# Access Compliance Report

## Public Rights-of-Way (Curb Ramps)

Intersection ID: 3539	Main Street: HARRIS_CORNERS_PY	Cross Street: MAPLE_VIEW_LN	Location: SW
ADA ID: 223A3AA9B78F	Ramp Type: Perp	Initial Pass/Fail: Fail	Overall Compliance: No
			Severity Score: 25

### Codes/Mitigation Info/Possible Solution

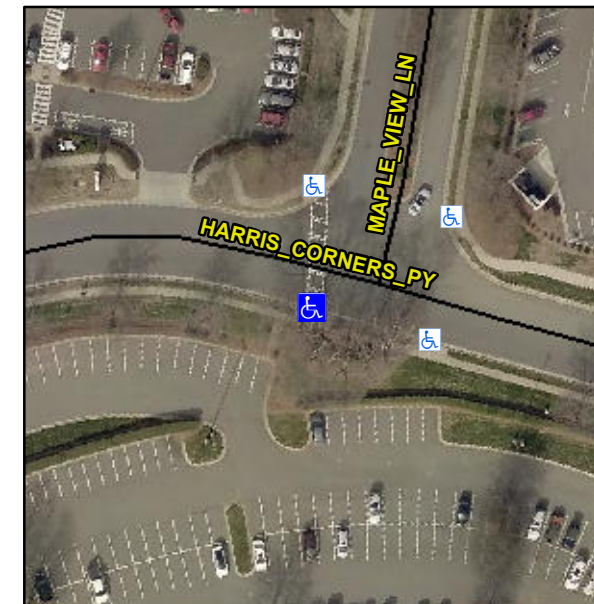
Compliance	Description	Data	Compliance	Description	Data
N/A	Ramp Length (in)	47.0	No	Ramp Slope (%)	14.9
Yes	Ramp Width (in)	50.0	Yes	Ramp XSlope (%)	0.1
N/A	Flare Type LT	N/A	N/A	Flare Type RT	N/A
N/A	Flare Slope LT (%)	N/A	N/A	Flare Slope RT (%)	N/A
N/A	Flare Traversable LT?	N/A	N/A	Flare Traversable RT?	N/A
N/A	Landing Length (in)	N/A	N/A	DWS Provided?	N/A
N/A	Landing Width (in)	N/A	N/A	DWS Contrast?	N/A
N/A	Landing Slope (%)	N/A	N/A	DWS Length (in)	N/A
N/A	Landing X Slope (%)	N/A	N/A	DWS Full Width?	N/A
N/A	Landing Curb? (Y/N)	N/A	N/A	DWS Offset (in)	N/A
N/A	Shared Landing?	N/A			
N/A	Gutter Ponding?	N/A	N/A	Gutter Slope (%)	N/A
N/A	Gutter Lip Ht (in)	N/A	N/A	Gutter X Slope (%)	N/A
N/A	Painted X Walk1?	Yes	N/A	Painted X Walk2?	N/A
	X Walk 1 Direction	To N		X Walk 2 Direction	N/A
N/A	X Walk 1 Width (in)	88.0	N/A	X Walk 2 Width (in)	N/A
	X Walk 1 Slope (%)	0.7		X Walk 2 Slope (%)	N/A
	X Walk 1 X Slope (%)	0.4		X Walk 2 X Slope (%)	N/A

**Remove & Replace Entire Ramp.**

**R304.2.2**
